<u>Medway Commons – BrightPath Child</u> <u>Care Center – Minor Site Plan</u>

Re: Bright Path Child Care Center Minor Site Plan Review 67C Main Street Medway, Massachusetts

Bright Path Child Care Center Minor Site Plan Review June 9, 2022 Review Letter

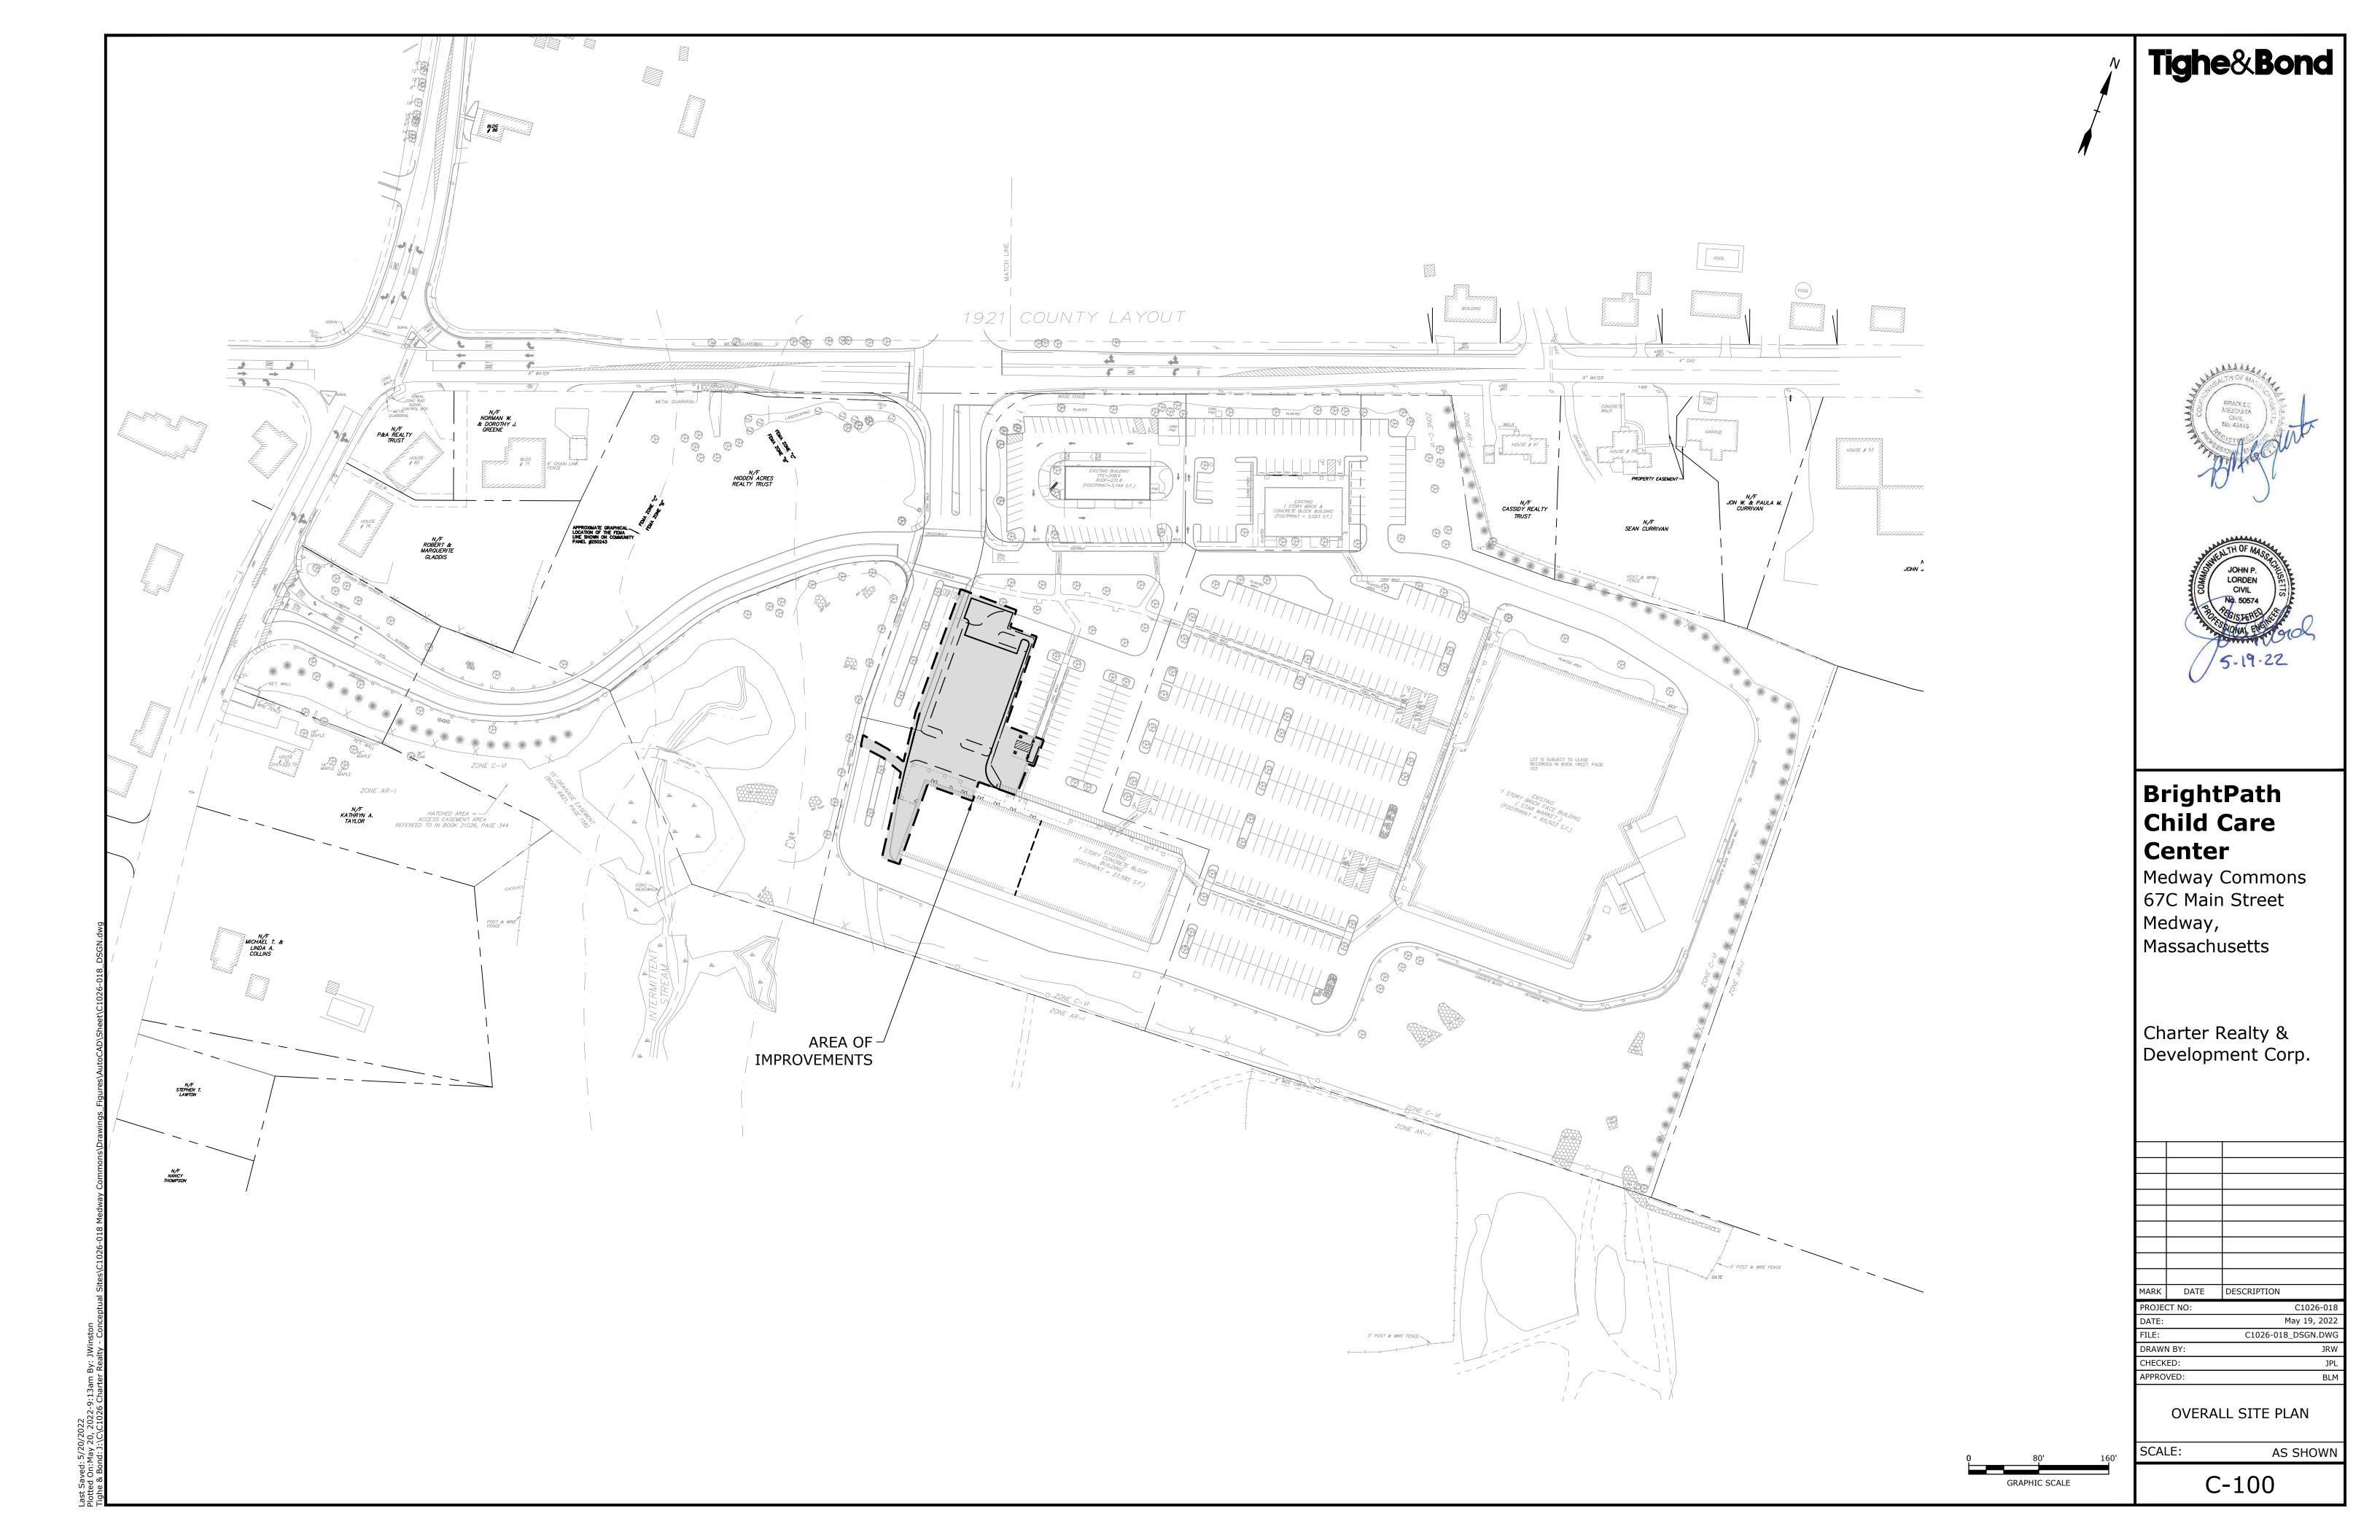
- 4. The Applicant shall provide bearings and distances of property lot lines, as well as display any applicable easements, for the existing lot shown on the Overall Site Plan (C-100). (Ch. 200 §205-5.C)

MARK	DATE	DESCRIPTION		
PROJE	CT NO:	C1026-018		
DATE:		May 19, 2022		
FILE:		C1026-018_DSGN.DWG		
DRAWI	N BY:	JRW		
CHECK	ED:	JPL		
APPRO	VED:	BLM		
DEMOLITION PLAN

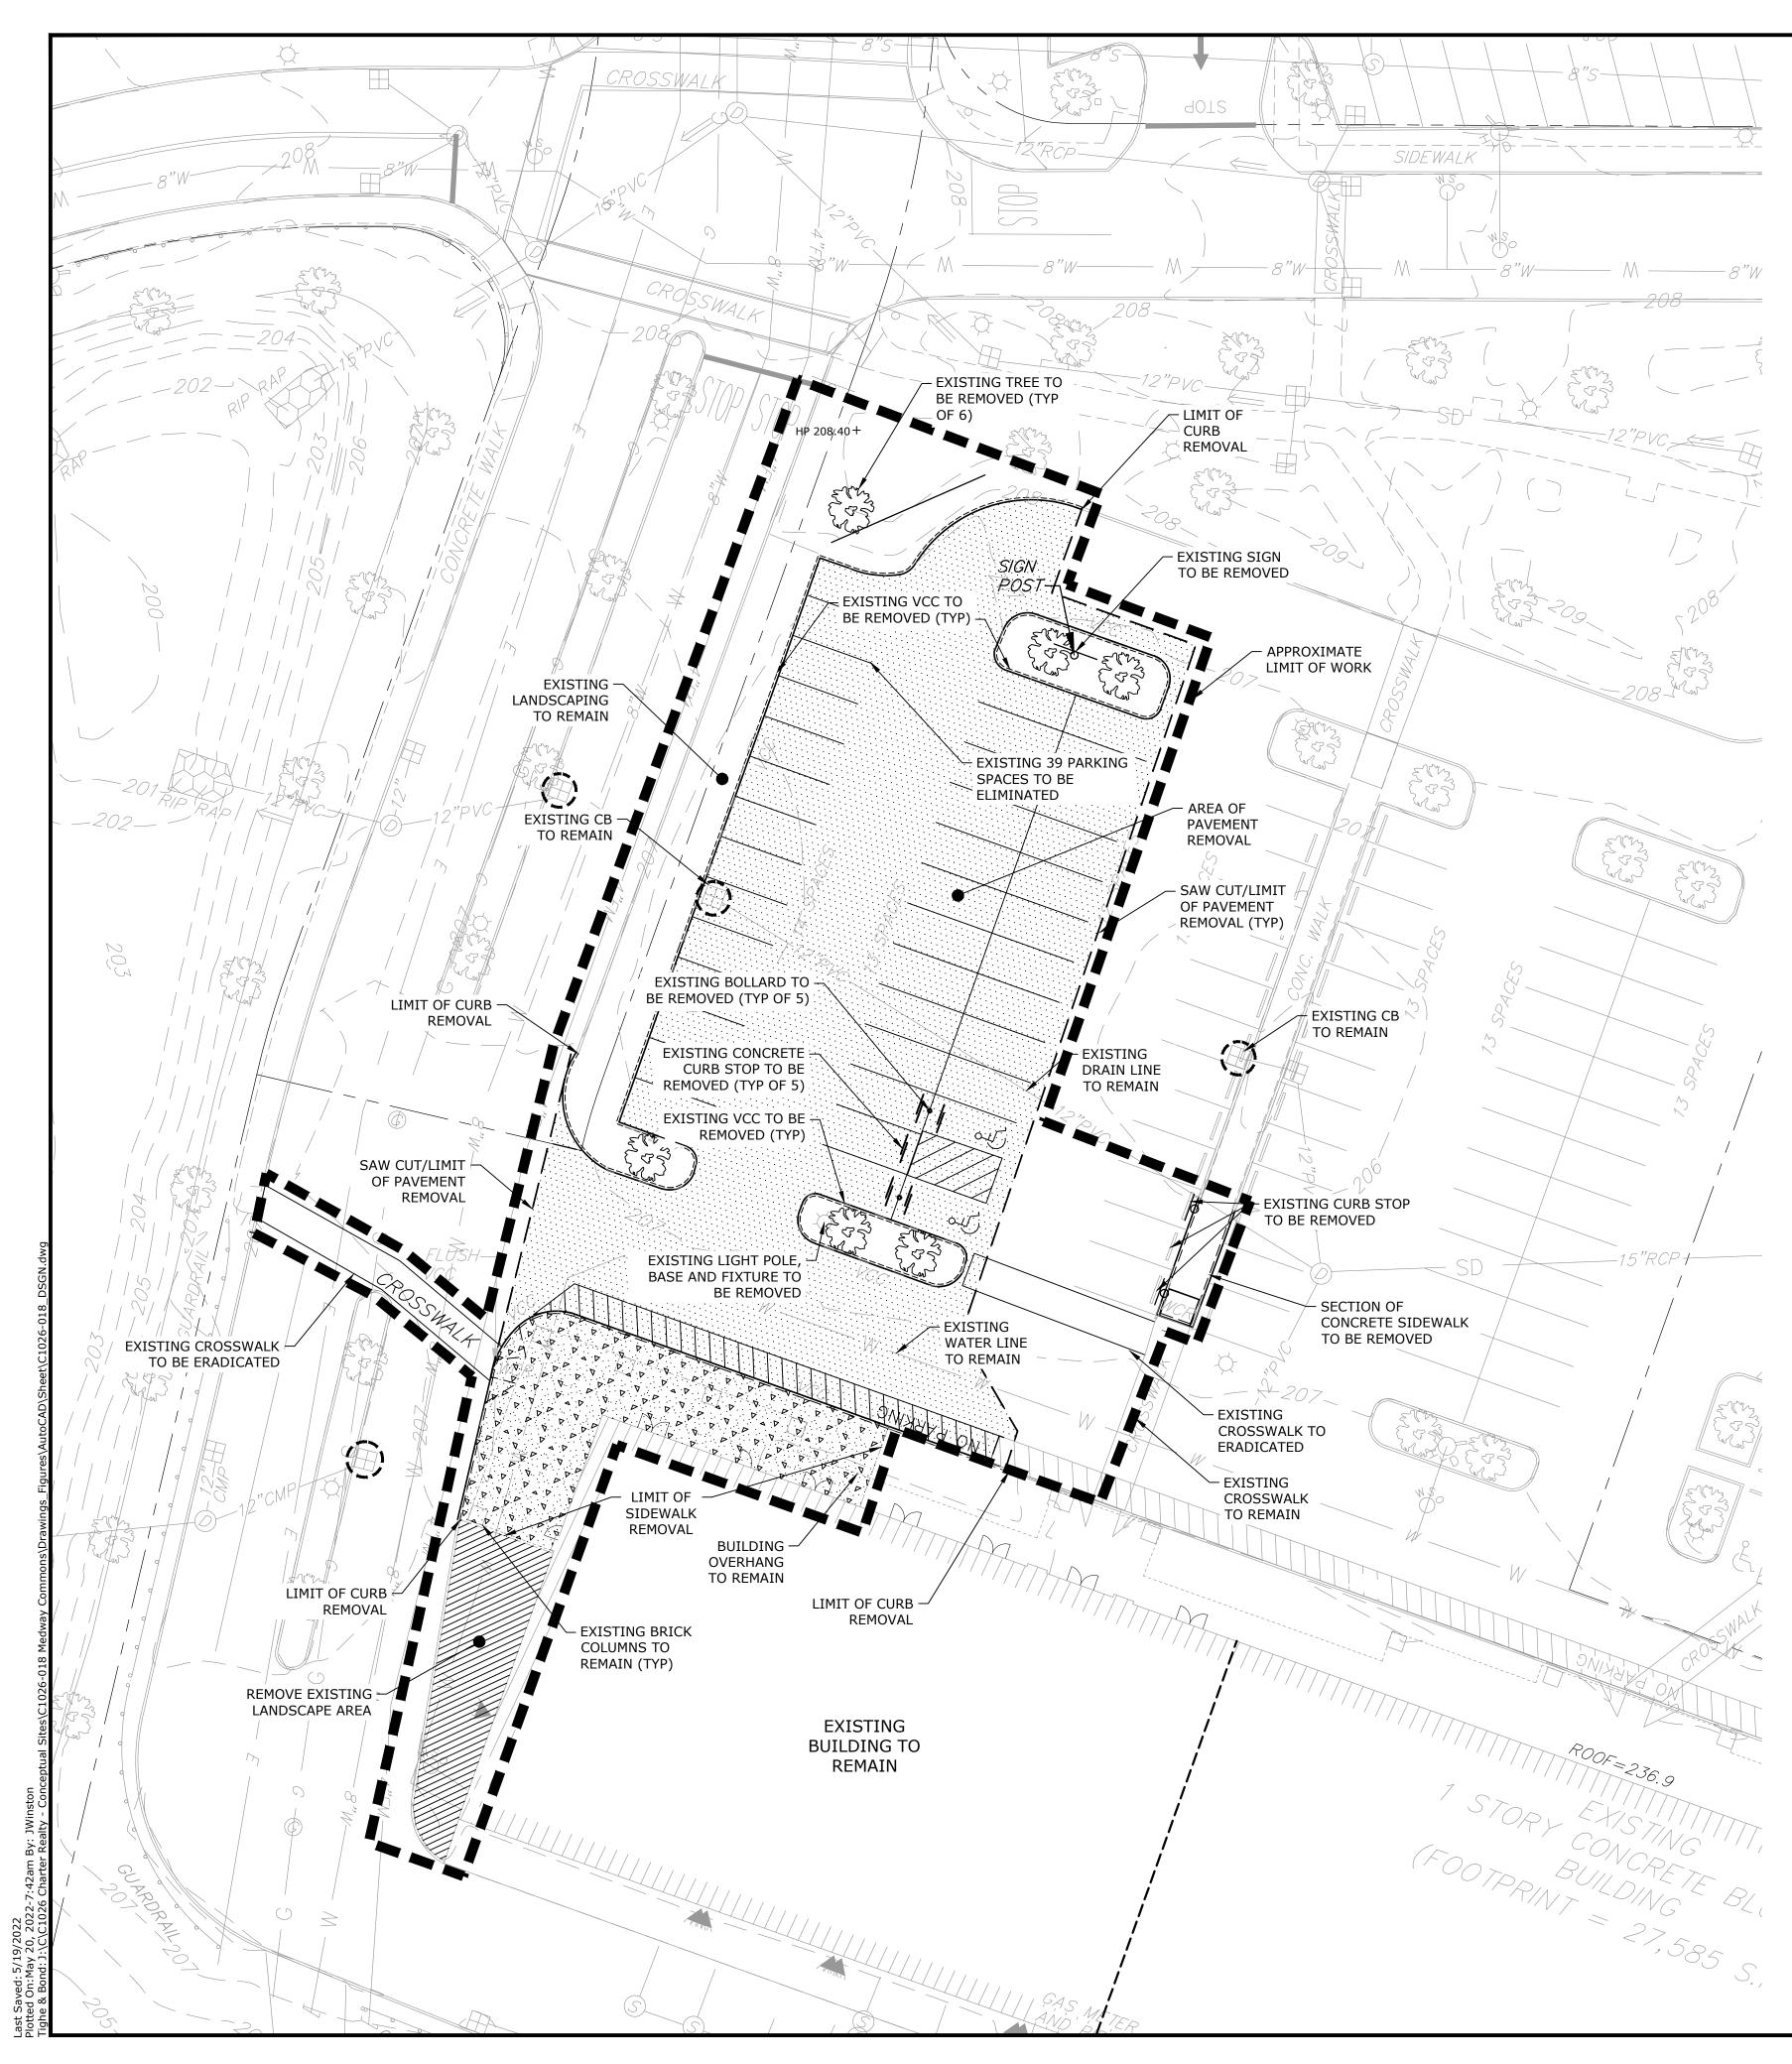
- 15. The Applicant should provide detail on the demolition plan for location of construction fencing and other means to protect the general public during construction at the site.

C-102

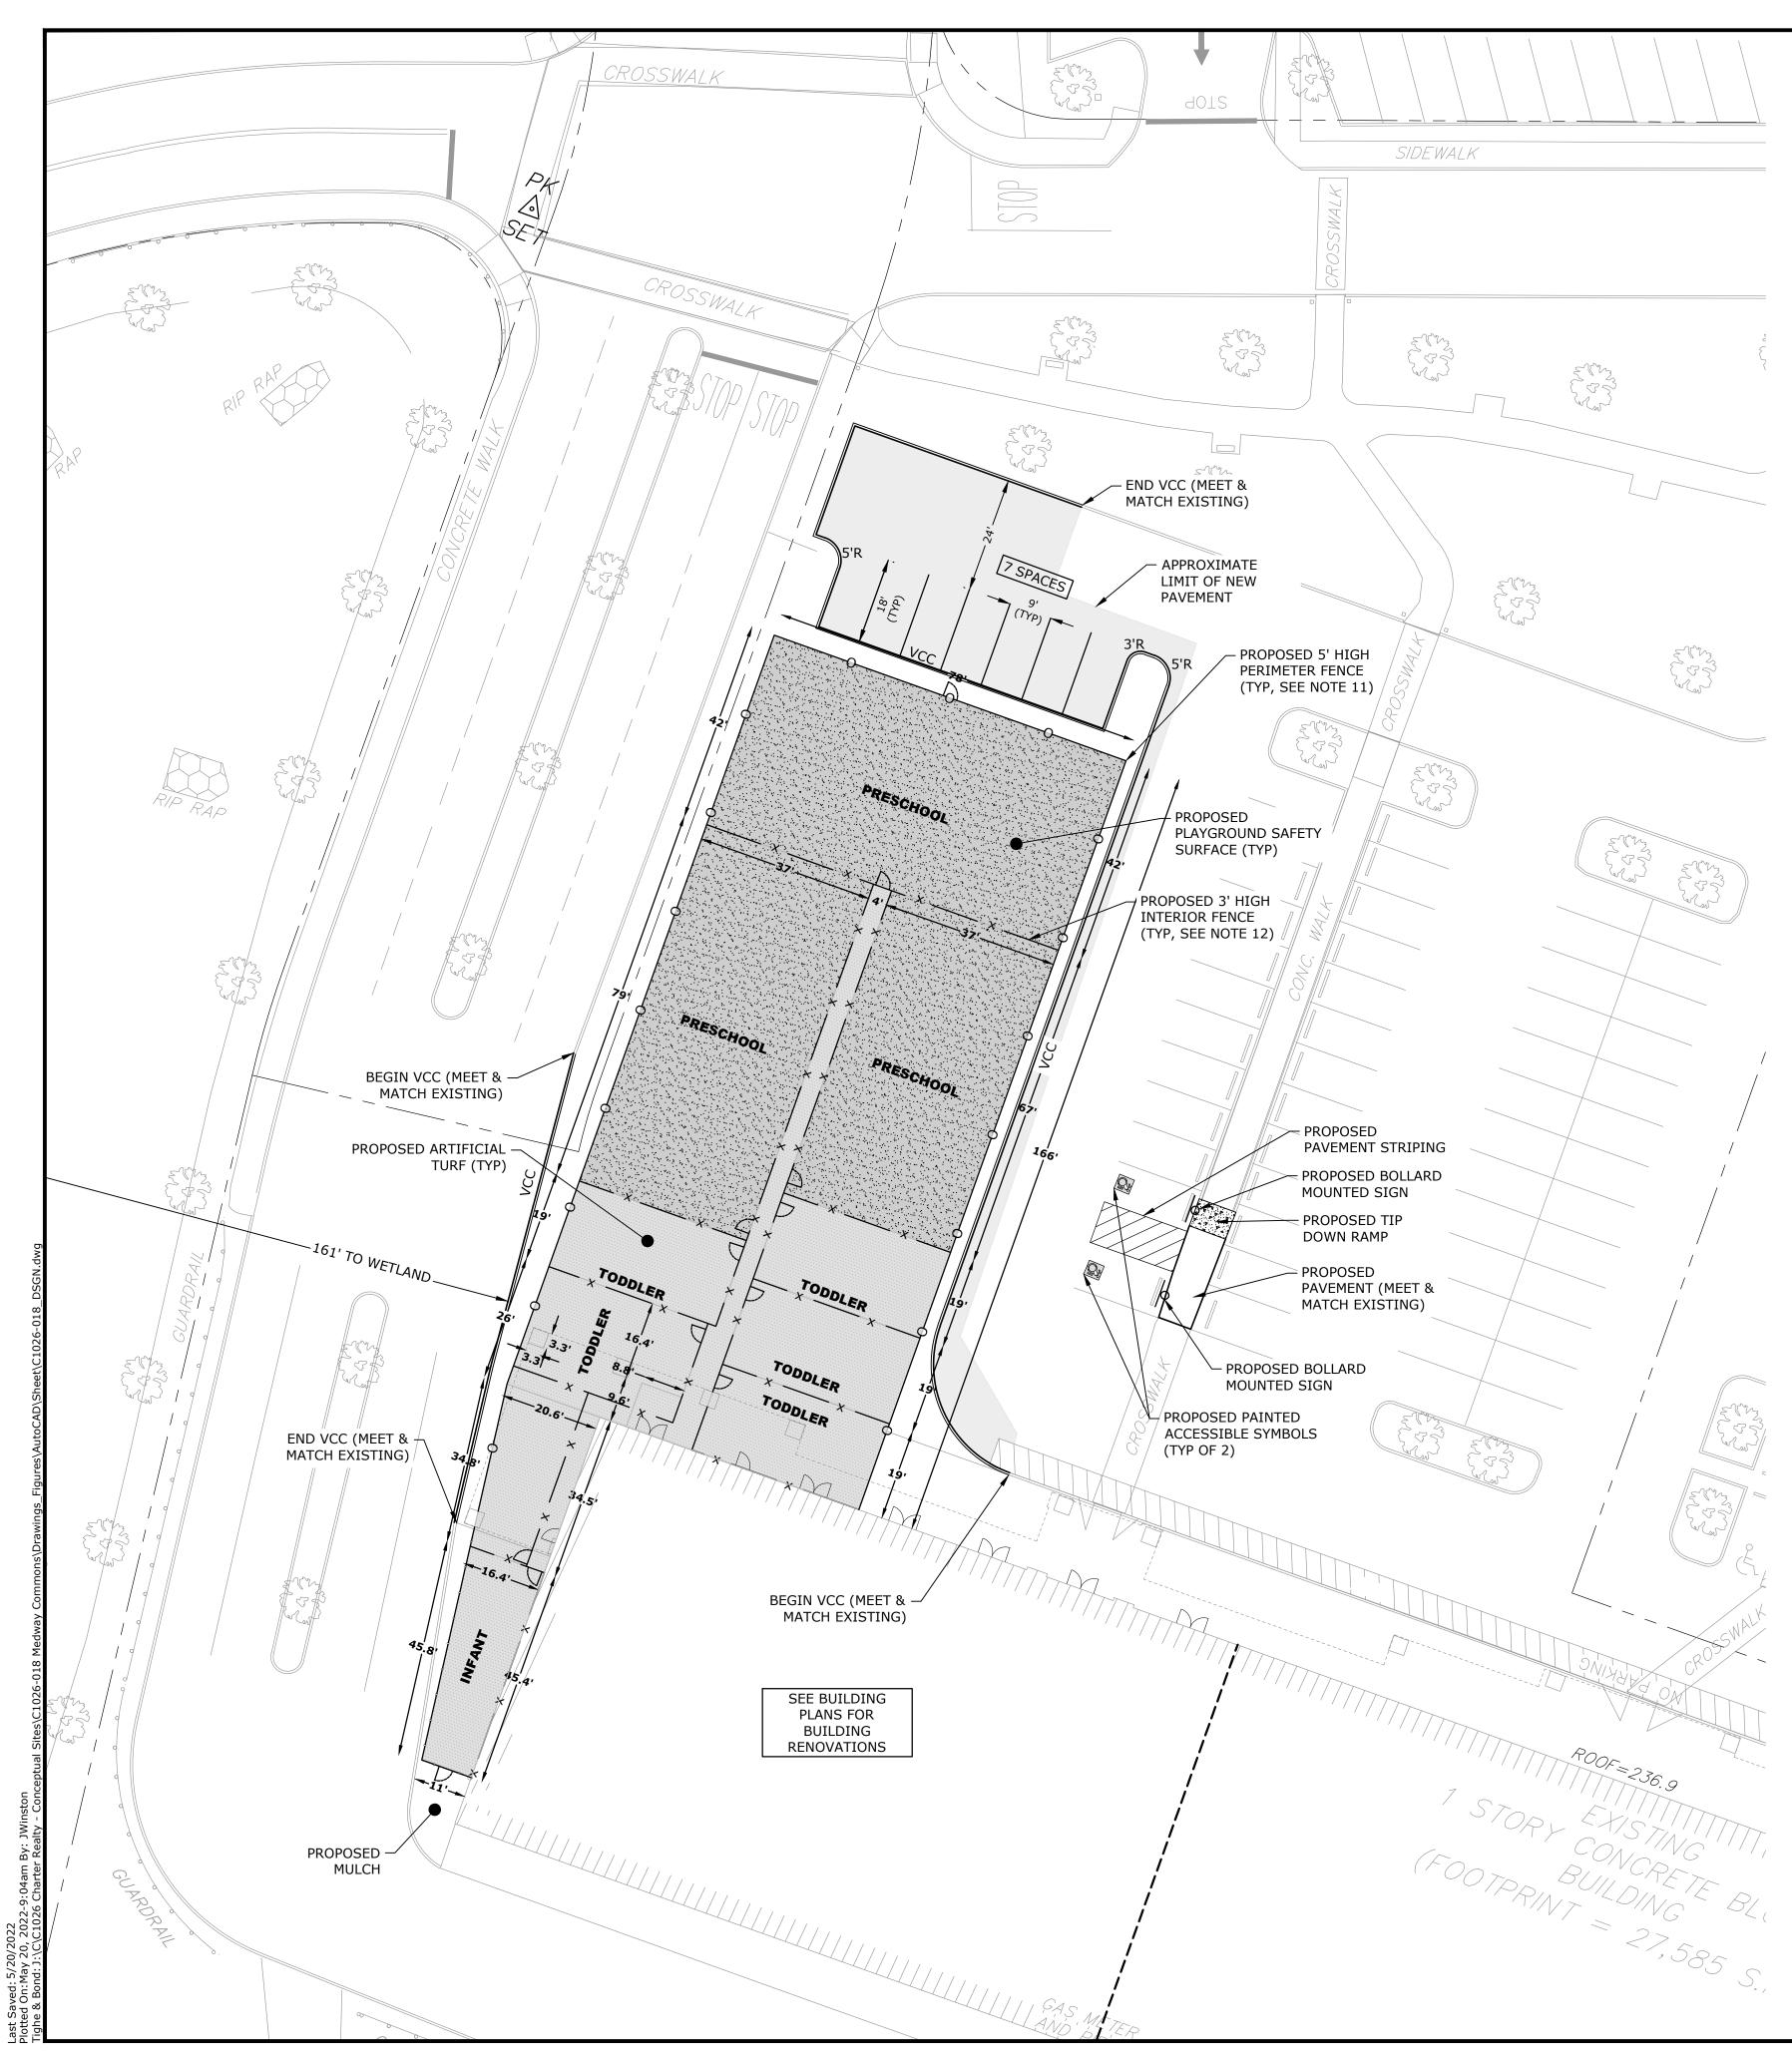
- 11. The Applicant is proposing to remove the existing crosswalk on the west side of the building. We recommend the sidewalk section to the north of the crosswalk also be removed to limit pedestrian traffic to a dead-end sidewalk with no formal crossing. This will also reduce impervious coverage at the site.

- 13. The Applicant should provide a smooth curb transition with a radius and tangent points to tie in the proposed curb to existing where the existing driveway is being removed on the west side of the playground areas.

- 16. A portion of the existing firelane along the front of the existing building is proposed to be removed and should be shown as repaved/restriped on the Plan.

- 17. The Applicant shall confirm on the plan the method of crosswalk striping removal. Grinding of pavement markings is preferred.

- 25. We recommend an island be added to the southerly portion of the parking aisle immediately adjacent to the east side of the daycare outdoor play area to provide a pedestrian refuge area and shorten the crosswalk distance to the main indoor doorway.
